Access Compliance Report

Public Rights-of-Way

(Curb Ramps)

Intersection ID: 18387	Main Street: BURTONWOOD_CR	Cross Street: MONROE_RD	Location: NE
ADA ID: 885EA78DED12	Ramp Type: PerpDiag	Initial Pass/Fail: Fail	Overall Compliance: No
			Severity Score: 26.25

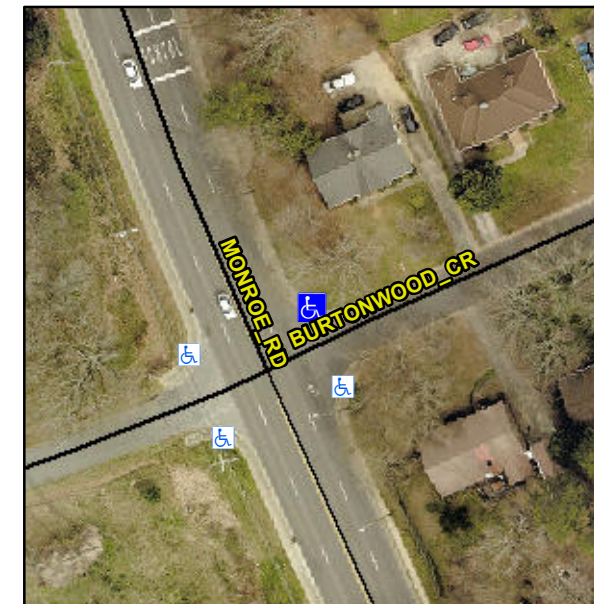
Not Found, R304.2.2, R304.5.3

Compliance	Description	Data	Compliance	Description	Data
N/A	Ramp Length (in)	58.0	No	Ramp Slope (%)	12.4
Yes	Ramp Width (in)	48.0	No	Ramp XSlope (%)	3.5
N/A	Flare Type LT	N/A	N/A	Flare Type RT	N/A
N/A	Flare Slope LT (%)	N/A	N/A	Flare Slope RT (%)	N/A
N/A	Flare Traversable LT?	N/A	N/A	Flare Traversable RT?	N/A
N/A	Landing Length (in)	N/A	N/A	DWS Provided?	N/A
N/A	Landing Width (in)	N/A	N/A	DWS Contrast?	N/A
N/A	Landing Slope (%)	N/A	N/A	DWS Length (in)	N/A
N/A	Landing X Slope (%)	N/A	N/A	DWS Full Width?	N/A
N/A	Landing Curb? (Y/N)	N/A	N/A	DWS Offset (in)	N/A
N/A	Shared Landing?	N/A			
N/A	Gutter Ponding?	N/A	N/A	Gutter Slope (%)	N/A
N/A	Gutter Lip Ht (in)	N/A	N/A	Gutter X Slope (%)	N/A
N/A	Painted X Walk1?	No	N/A	Painted X Walk2?	No
	X Walk 1 Direction	To W		X Walk 2 Direction	To S
N/A	X Walk 1 Width (in)	N/A	N/A	X Walk 2 Width (in)	N/A
	X Walk 1 Slope (%)	1.9		X Walk 2 Slope (%)	0.0
	X Walk 1 X Slope (%)	1.3		X Walk 2 X Slope (%)	1.3

Remove & Replace Curb Ramp With Two New Directional Ramps or Equivalent.
